Robinson Helicopter Company

MANDATORY SERVICE BULLETIN #14

SUBJECT: Failure of the A041-2 damper clip

ROTORCRAFT AFFECTED: R22 helicopters, Serial Numbers 0002
thru 0220

figure 1

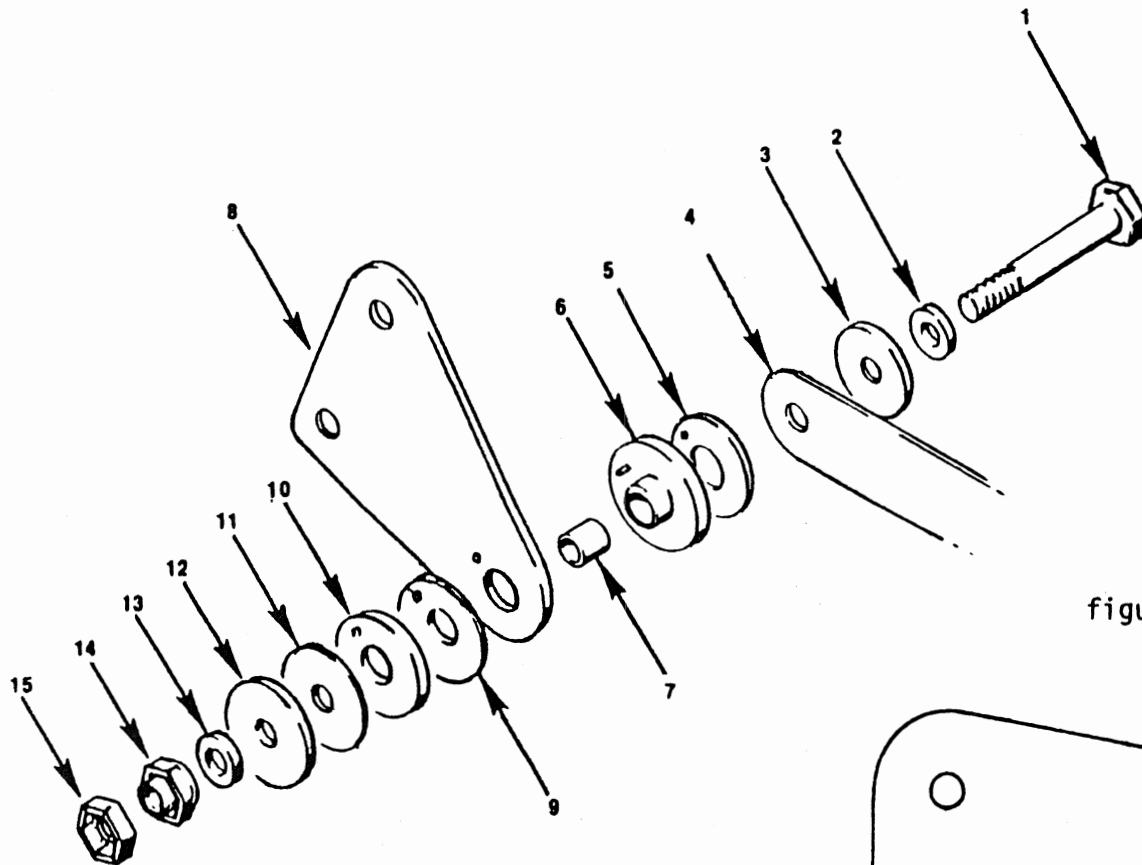
BACKGROUND: There have been two reported incidents of Tail Rotor drive shaft damper clips (part number A041-2) fracturing in flight after suspected overspeeds. The fractured damper clips allowed the drive shaft to whip inside the tailcone. Safe landings were made. However, a fracture of the damper clip could cause failure of the Tail Rotor drive shaft and loss of directional control.

- a) Within the next 25 hours or sooner, replace the aluminum A041-2 damper clip with the enclosed steel A041-2, Rev H, damper clip.
- b) Following any suspected rotor overspeed or hard landing, immediately inspect the Tail Rotor drive shaft for excessive run-out per Robinson Service Letter #14. Also inspect the Tail Rotor drive shaft damper clip and bracket for possible bending.

8. Remove the Tail Rotor drive shaft from the tailcone.
9. Carefully disassemble and reassemble the damper per the following steps for the A041-2 clip replacement (see fig. 1).

- a) Remove items 9 thru 15 in figure 1.
 - b) Remove the A041-2 aluminum clip and replace with the A041-2 steel clip enclosed with this bulletin.
 - c) Reinstall items 9 thru 15.

Be sure the small dowel pin is lined up with the holes in items 8, 9, and 10 before tightening nut.

- d) Torque the NAS679-A3 nut to 35 to 40 in-lbs. Hold the A041-3 arm (item 4) and attach a spring scale or dead weight to one bolt hole in the A041-2 clip (item 8). It should take 1 to 2 lbs. to move the clip.

If drag is less than 1 lb., check the A041-6 spring washer (item 9) and bend washer until it has a total height of .070 \pm .010 inch. If the spring washer is OK, but the drag is still too low, sand metal from the end of the A105-9 journal (item 7). If drag is greater than 2 lbs., flatten washer slightly.

DO NOT ADJUST THE DAMPER DRAG BY CHANGING THE BOLT TORQUE

- e) Retorque the NAS679A3 nut to 35 to 40 in-lbs., recheck the damper drag. Install the MS27151-7 palnut and torque stripe.
14. Reassemble using the reverse of Steps 1 through 8 of this procedure and the Robinson R22 Maintenance Manual, Section 8. Torque values are given in Section 12.
15. Each operator will be invoiced for a new A041-2 clip. After replacing the aluminum clip with the new steel part, return the old part to RHC for full credit. Return of the old parts is necessary to comply with FAA requirements to account for all aluminum parts.
